UNITED STATES PATENT AND TRADEMARK OFFICE

Office Action Summary	Application No. 10/783,499	Applicant(s) ZIPFEL ET AL.	
	Examiner Michael B. Shingleton	Art Unit 2815

DETAILED ACTION

Comparison Illustration.

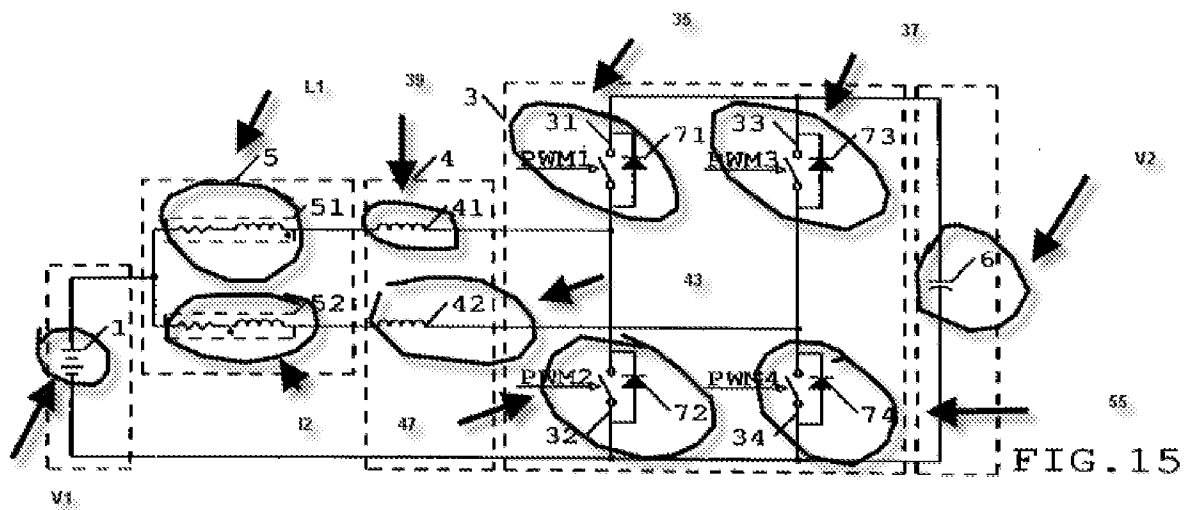
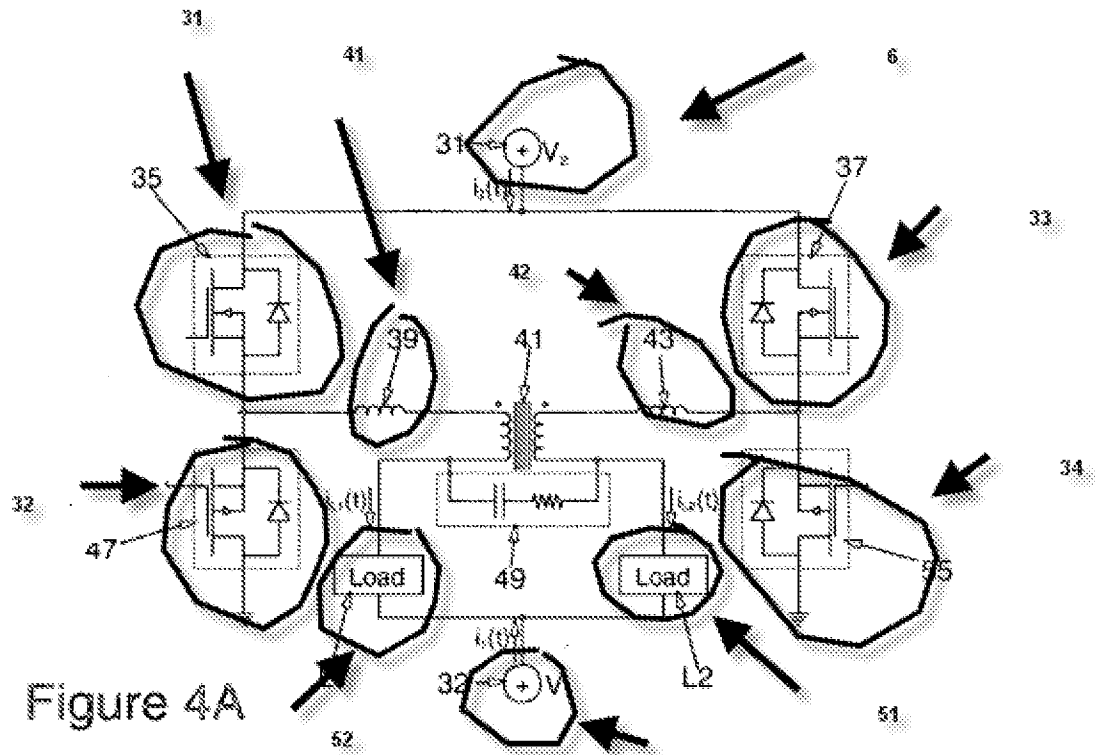
Applicant appears to make an issue of the PWM signals being “in-phase” with transistors 35 and 37 of the disclosed invention being both roughly “on” at the same time (See page 12 around line 23 of the instant application.), as compared to what might be considered “out of phase” pwm signals of the prior art where transistor 31/PWM1 is “on” and transistor 33/PWM3 is “off” roughly at the same time in the prior art. See column 7 around line 61 of Prokin., but in actuality the baseband signals of both the prior art and the present invention that are applied to their two respective loads appear to be 180 degrees out of phase and thus the instantaneous currents through the first and second reactive loads is substantially zero just like claim 1 has been amended to read (This is addressed in the rejections in more detail.). Also the fact of the matter is that at least the independent claims are just not so limited to the PWM signals being “in-phase” as apparently meant by applicant and these claims are more directed toward the description of the function of having the baseband signals applied to the two loads being out of phase with each other which the prior art clearly, i.e. inherently, includes, as is addressed in more detail in the rejection(s). As also noted the claims just do not claim the specific structure of the transistors/switches 35, 37, 47 and 55 of Figure 4A, but even if applicant did claim the specific structure of the transistors/switches 35, 37, 47 and 55 of Figure 4A the structure is the same with that of the switches 31, 33, 32, and 34 of the prior art. The inverter and load structure of the prior art and the disclosed invention are the same as addressed in the previous office action.

Again as stated above, the prior art has the same result as applicant's invention and as noted in the previous office action there is no difference in the inverter/load structure between the disclosed invention and the invention of the prior art. Also see the "Comparison Illustration" above. These two methods of operating, i.e. the preferred method of the prior art and the preferred method of the instant application are also looked upon as two art-recognized equivalent methods of operating the same device. Again many of the claims of applicant's invention are directed toward structure and the structure is not different between the prior art and applicant's disclosed invention. Thus this discussion between the difference between the method of the disclosed invention and the preferred method of the prior art does not have much bearing on the claims as the claims presented are not method claims but claims drawn to structure and most if not all of the claims don't even relate to the so called "in-phase" and "out-of-phase" PWM signals. However, it is important to note so as to understand the rejection and respond to applicant's arguments as these arguments are directed more toward a method and not a structure. In the disclosed method of the instant application the two baseband signals are caused to be out-of-phase by using the inverse of the baseband signal to be applied to only "one side" of the inverter structure to come up with one of the two PWM signals, i.e. the "PWM" signal. How one intends to use an old structure does not define a different or new structure. The old structure still remains an old structure. Also it has been long held that the discovery of how the prior art works does not present patentable distinction in claims drawn to structure. Also additionally as pointed out to the applicant many times in claims drawn to structure, the claims must be distinguish by structure. MPEP 2114 clearly states that "while features of an apparatus may be recited either structurally or functionally, claims directed to an apparatus must be distinguished from the prior art in terms of structure rather than function. In re Schreiber, 128 F.3d 1473, 1477-78, 44 USPQ2d 1429, 1431-32 (Fed. Cir. 1997)". Note that the Schreiber case was directed toward the pop corn funnel and the prior art did not recite the concept of using the prior art for pop corn, however, the structure claimed was met by the prior art. If an old structure is capable of performing the function then this old structure will clearly meet claims reciting these functions. If one applies PWM and PWM' signals to the prior art structure of Prokin such that the signals cause transistors 31 and 33 to be "on" about the same time ("in-phase") and the baseband signal super-imposed on the PWM' signal to transistors 33 and 34 of Prokin is the inverse of the baseband signal then Prokin would function exactly as the disclosed invention, so there is no question that the device of Prokin is fully capable of functioning the same as the disclosed invention. It is noted that the claims are much broader in the reciting function than in the disclosed invention, but this only shows that if applicant were to include more narrow limitations of pure intended use that the Prokin may be fully capable or performing the intended use.

Basic Illustration 1.

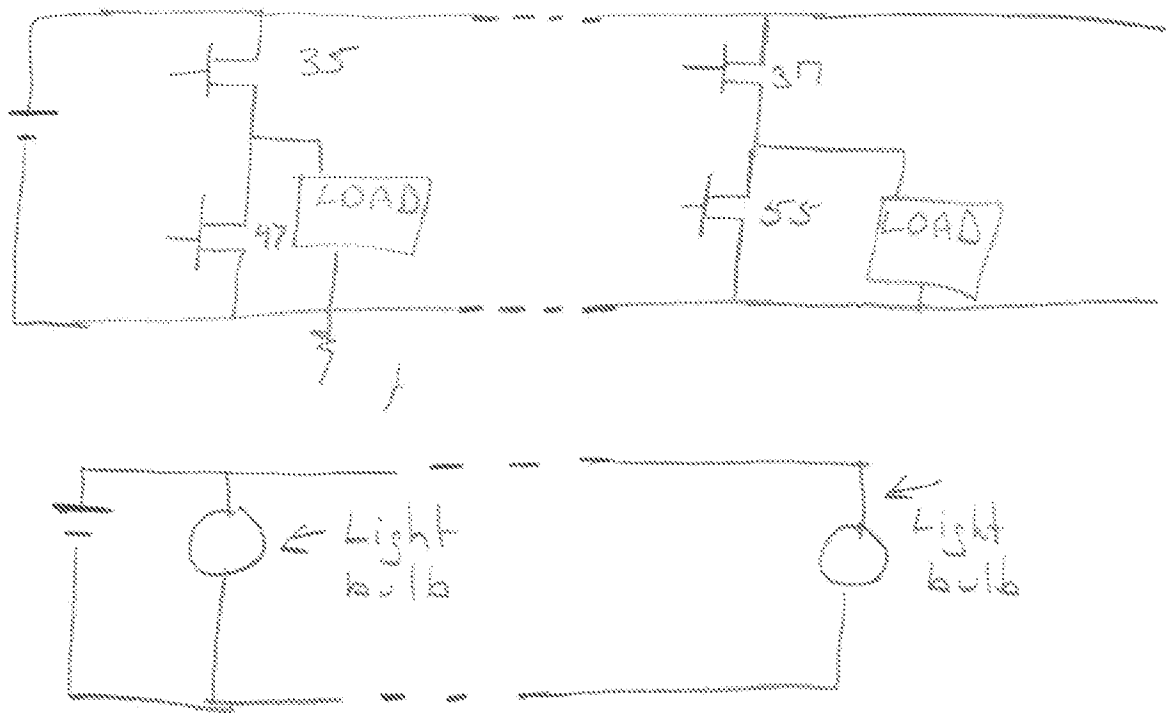
The examiner also feels that it is necessary due to applicant's remarks/arguments and to make clear to others some basic engineering features involved. It is just a common fact that in circuit analysis that a DC source acts as a short to an AC signal. So applicant's invention is more in tune to two separate push-pull or inverter arrangements that share a common ground. This is like separate light bulbs connected in parallel. Prokin also recognizes this fact in its illustration of Figure 11. The illustration below illustrates the basic arrangement of both Prokin and applicant's invention. See Basic illustration 1.

Basic Illustration 2.

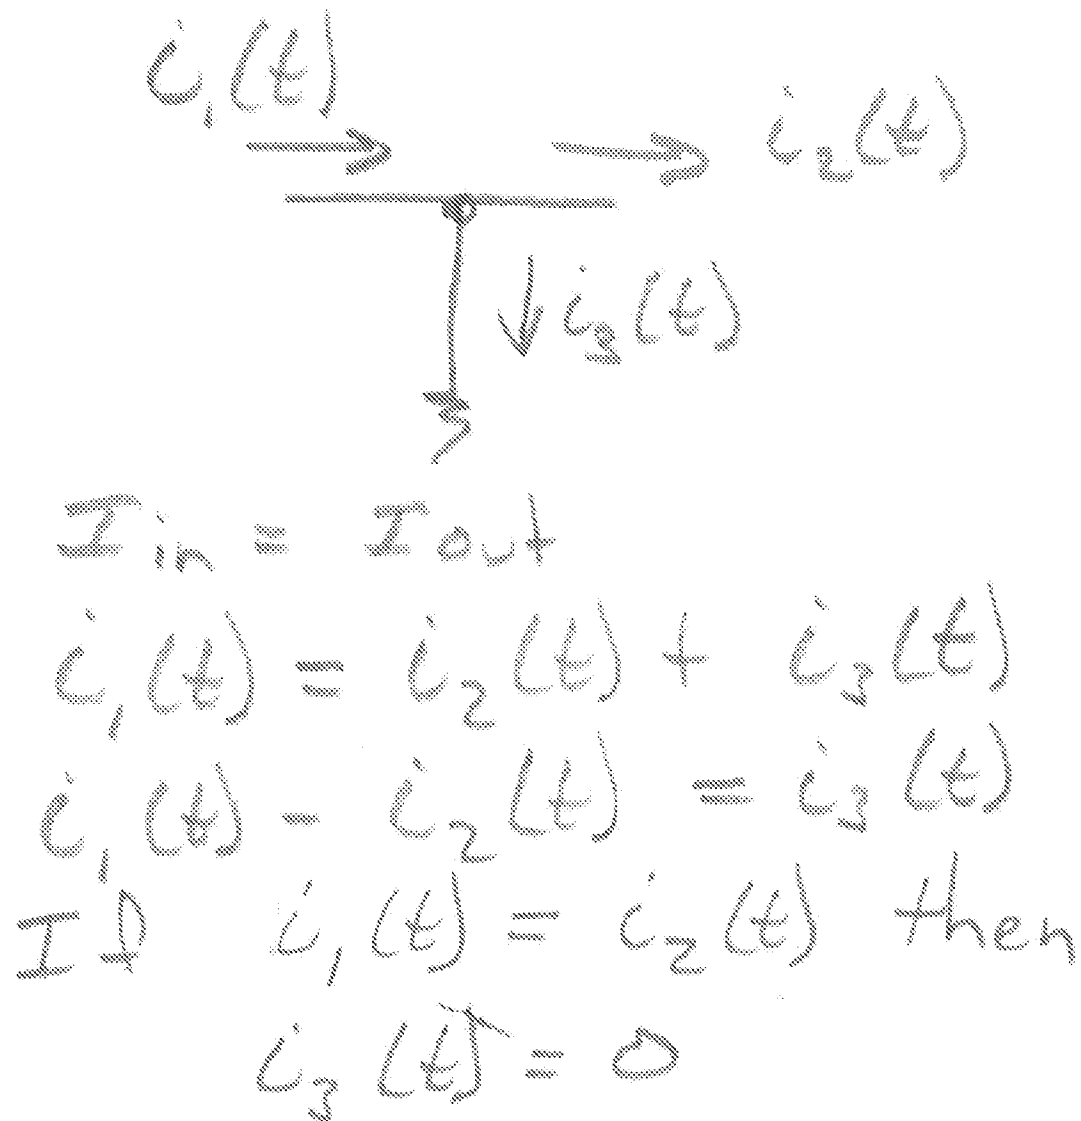
When the baseband currents are equal and opposite through the two loads then there is no baseband current through the “ground lead” as illustrated above. This is what occurs in Prokin and is the subject of the alternative description of the same function of the invention as presented in claim 9 and compared to claim 1. This fact that there is no current is based on the fact that the current into a node must equal the current out of the node, a basic engineering feature. With this then what flows into this node from one load is the current that flows into the other load. Again this is what happens in Prokin as

Speaker illustration number 2.

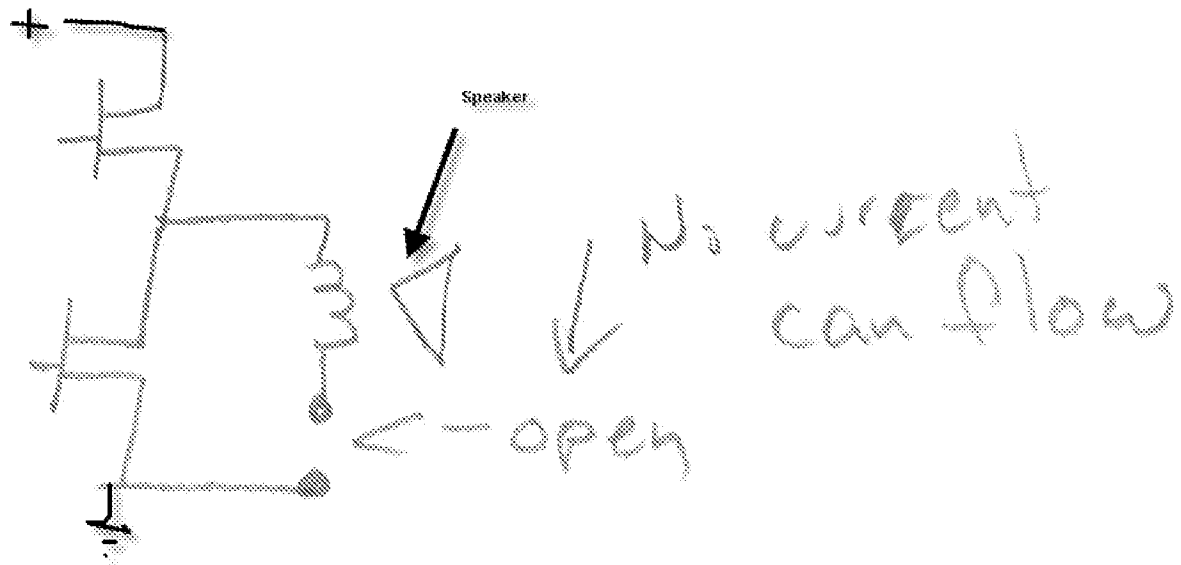
will be discussed in more detail below. Also note that if the DC source did not act as a short to AC, but as an open circuit then it would be impossible for the basic inverter or push pull unit like that of applicant's invention and that illustrated in Figure 11 of Prokin to have a return current path and thus the speaker would not speak or work. See Speaker Illustration number 2.

Figure 4a of the instant application.

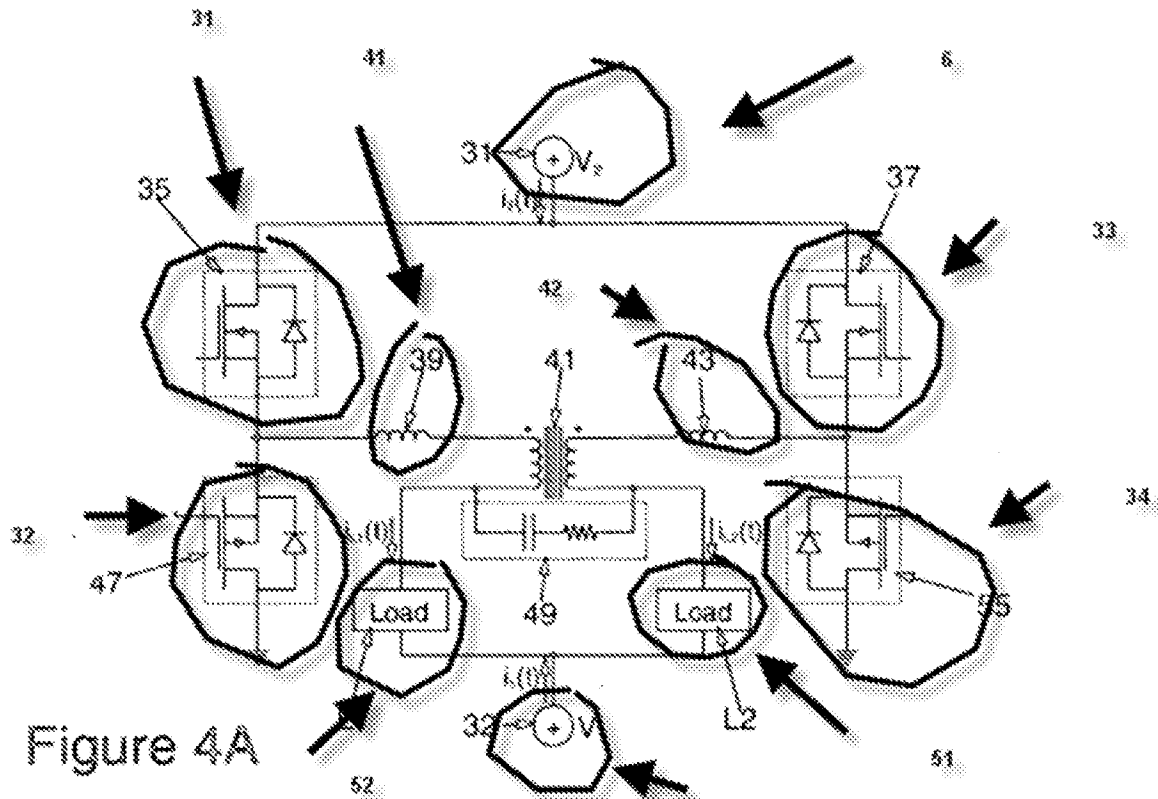
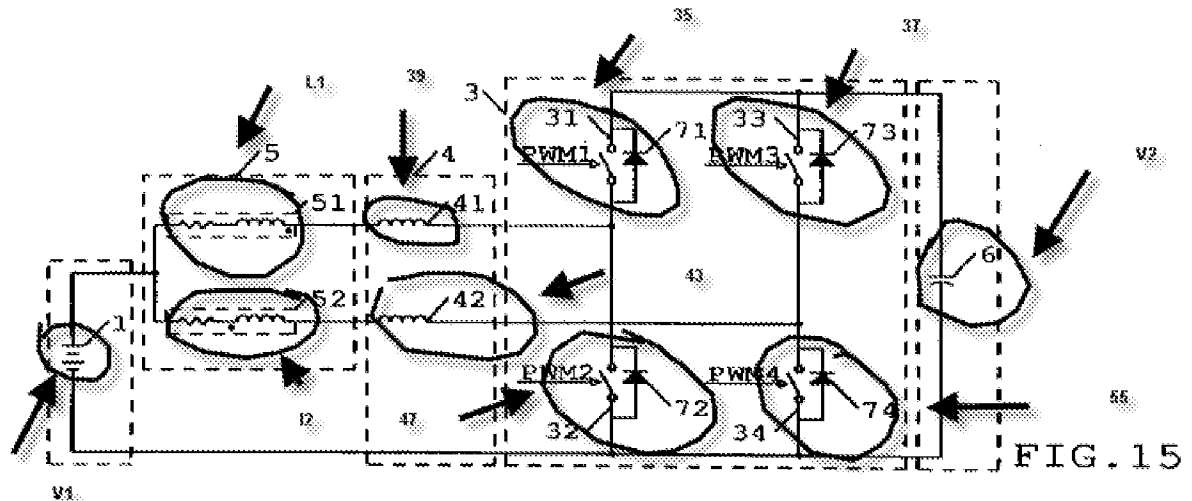
See elements 31 and 32 are part of the means that forms a first switching signal and elements 33 and 34 that forms a second switching signal of Prokin. Compare that to the disclosed invention of Figure 4a. The switching band component is the same as that of applicant's disclosed invention and that is a square-wave and as mentioned above the device of Prokin is for an audio function (It is to power voice

coils.) wherein the baseband component is applied by the pulse width modulation of the square-wave just like that of applicant's disclosed invention. (See Figure 4a of the instant application and Figure 15 of Prokin.)

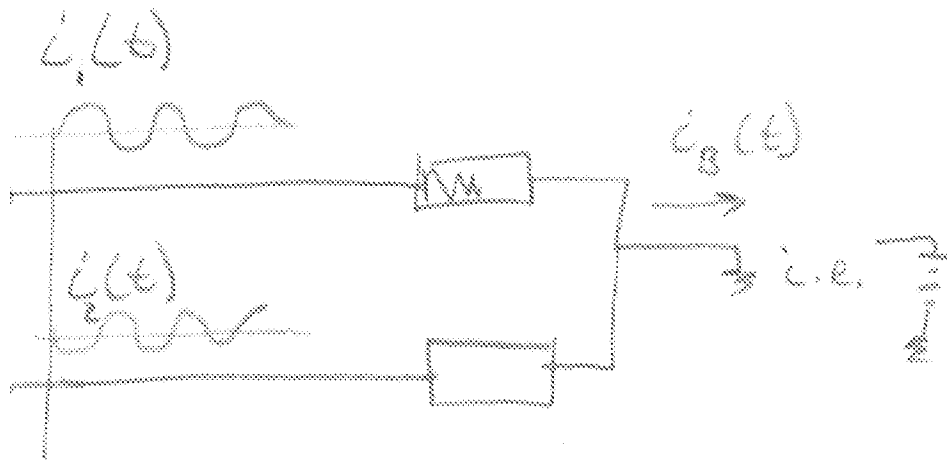
See the two wires that are used to apply the switching signals to the loads as illustrated above.

Note that other elements of the prior art could also meet this claim language limitation.

Speaker illustration number 1.

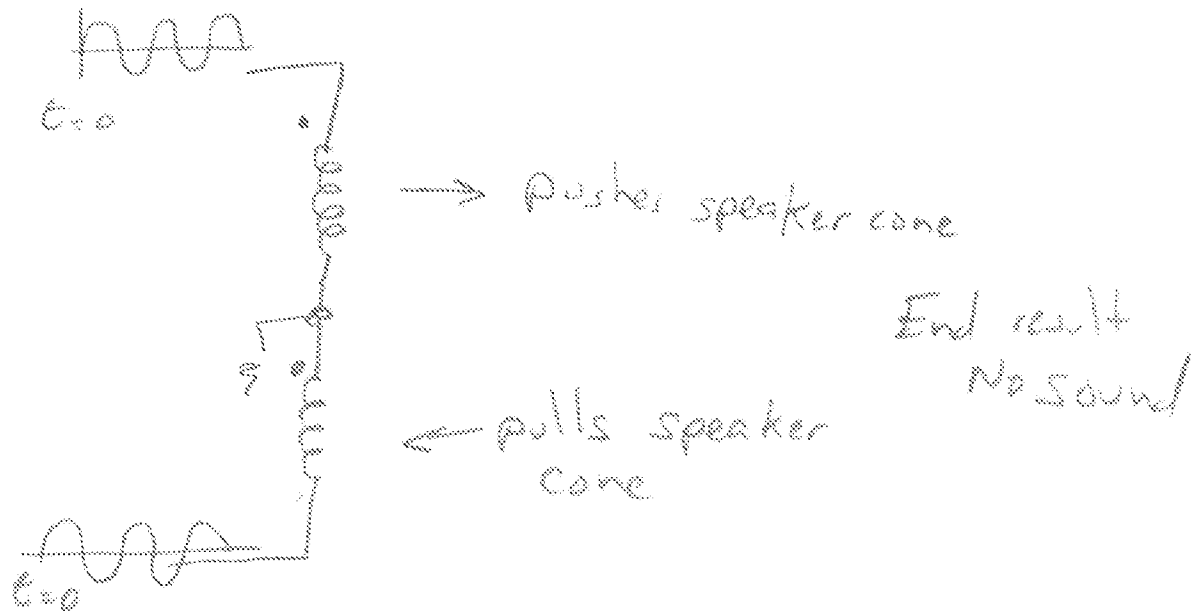
As noted above the baseband signals that are applied to the two loads in the Prokin prior art are out-of-phase just like that of applicant’s invention. This inherently exists because of the “alternative” switching of the inverter transistors in the Prokin arrangement as noted above and more particularly this is further supported by the fact that in one preferred embodiment of Prokin a dual coil speaker is used. Note the “dot convention” of Figure 15. If the base band signals were not complementary or of opposite phase then the speaker would not produce any sound as the voice coils would cancel each other out. See the drawing called “Speaker illustration number 1” below that should help applicant see this fact.

Push Pull illustration.

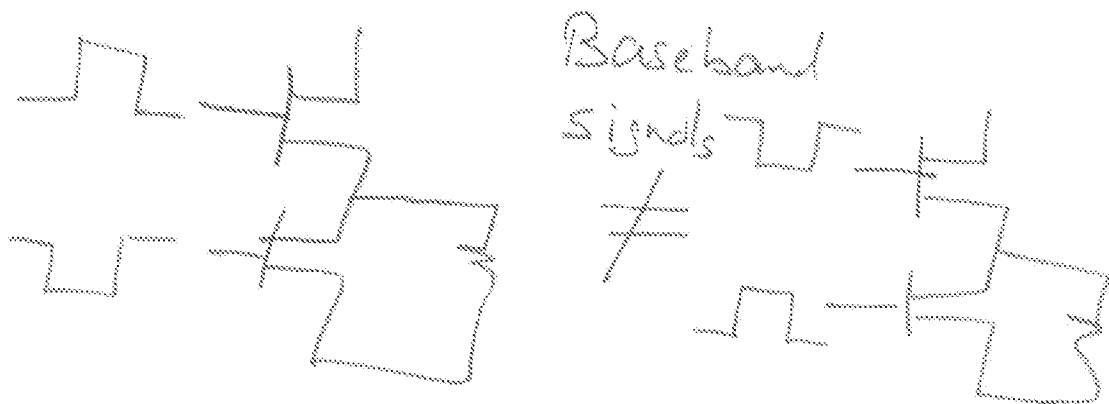
To further illustrate this fact that the baseband currents are of opposite magnitudes note the push and pull nature of the Prokin prior art, i.e. the "alternative" switching. See push pull illustration below.

In the Push Pull illustration note that with the exact opposite PWM signal applied to the "pull" transistor as compared to the "push" transistor the baseband signal just cannot be the same and are in fact 180 degrees out of phase with each other. To explain this in more simple terms note that when you filter out the high frequency signal what you have left is the width of the pulses defining how much the positive magnitude is (Push) and how much the "negative"(ground) magnitude is (pull). When the pull magnitude is at the highest in one push/pull arrangement the Push magnitude is at its highest in the other push/pull arrangement. In other words the baseband signals are opposite or 180 degrees out of phase between the two push/pull arrangements. (Note that the claims are drawn to structure so even if the examiner were to be incorrect in baseband signals are not the same for the two push pull circuits operated in an opposite manner as illustrated in the push pull illustration above, still applying the yet unclaimed disclosed control signals to the prior art does not impart patentability to the structure as the structure is the same and merely applying signals to an old structure that is different from the norm does not make that structure new. It is the same old structure. What applicant will be getting should this application become a patent is the right to exclude others from making the claimed structure. **There must be no "ambiguity" as to what that structure is.** See Halliburton Energy Services, Inc. v M-I LLC, Fed. Cir. 2007-1149. The examiner has constantly pointed to MPEP 2114 where the patent office requires this of the claims. Thus what is needed here in this application is clear limitations of structure to distinguish over the prior art so as to provide a clear indication to the public as to what structure applicant will be allowed to exclude others from making should this application become a patent.)
